# UNITED STATES PATENT AND TRADEMARK OFFICE

| APPLICATION NO. | FILING DATE | FIRST NAMED INVENTOR   | ATTORNEY DOCKET NO. | CONFIRMATION NO. |
|-----------------|-------------|------------------------|---------------------|------------------|
| 10/725,065      | 12/01/2003  | Yueh-Se (Joseph) Huang | GP-303205           | 2738             |

## Office Action Summary

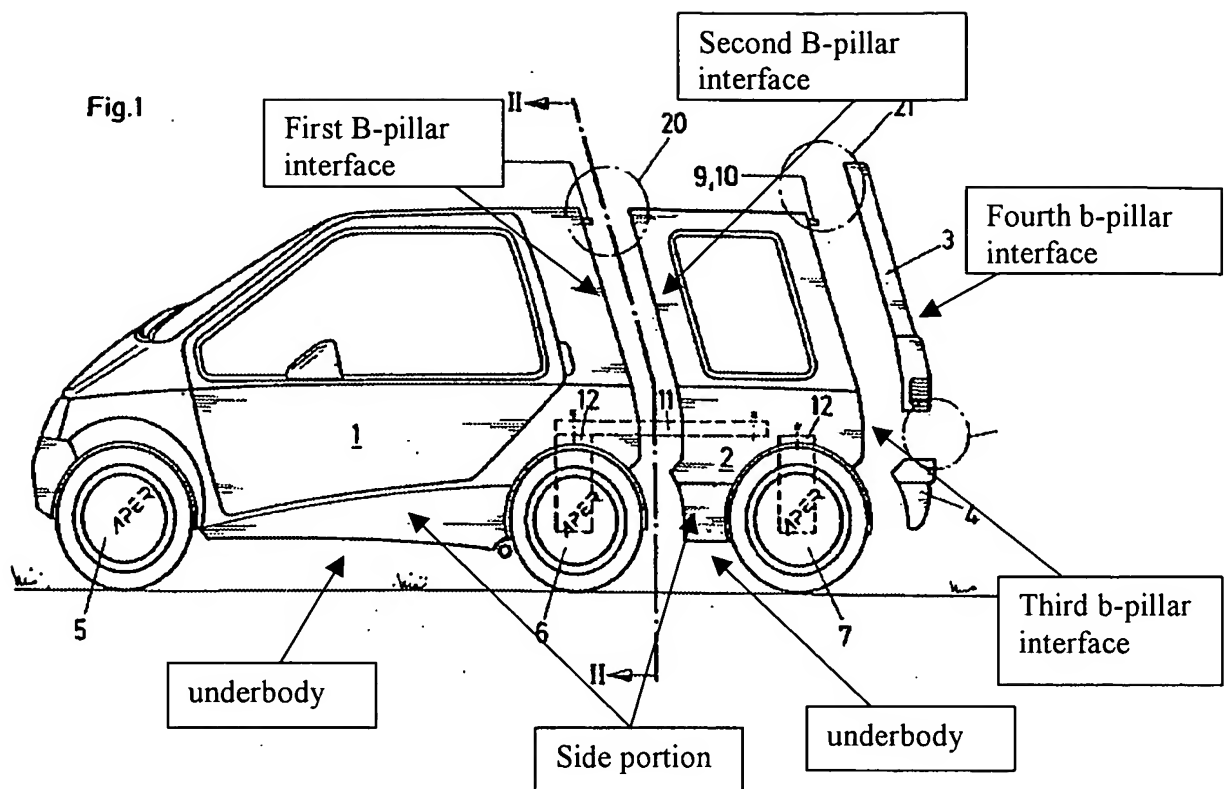
Regarding claims 1 and 8, Aper discloses a modular body for a vehicle, comprising: a first module (1) having a first B-pillar interface (see below); and a second module (2) having a second B-pillar interface (see below); wherein the first (1) and second (2) modules are joined at the first and second B-pillar interfaces defining a B-pillar thereat.

Regarding claim 2, Aper discloses the modular body of Claim 1, wherein: the first module (1) includes two side portions (Fig. 2) and an underbody portion (Fig. 2); the second module (2) includes two side portions and an underbody portion; and the underbody portions of the first and second modules make up an underbody portion of the vehicle (see illustration above).

Regarding claim 4, Aper discloses the modular body of Claim 1, wherein the second module (2) further includes a third B-pillar interface (see above), and further comprising: a third

module (3) having a fourth B-pillar interface (see above); wherein the second (2) and third (3) modules are joined at the third and fourth B-pillar interfaces defining a second B-pillar thereat.

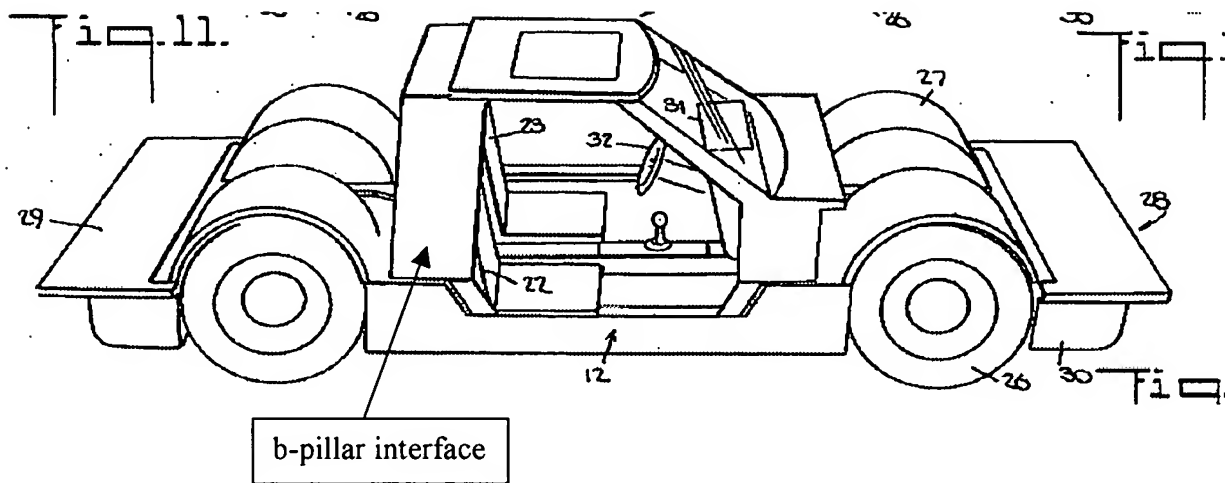
Regarding claim 6, Aper discloses the modular body of Claim 1, wherein the first and second B-pillar interfaces are slidably engaged (in Fig. 3, the bolt 9 which joins the two modules together is welded onto the first module (via bracket 8) and therefore the second module slide onto the bolt of the first module) with each other.

Regarding claim 9, Aper discloses the modular body of Claim 8, further comprising: a complete underbody (see above) made up from an underbody of the first module (1) and an underbody of the second module (2).
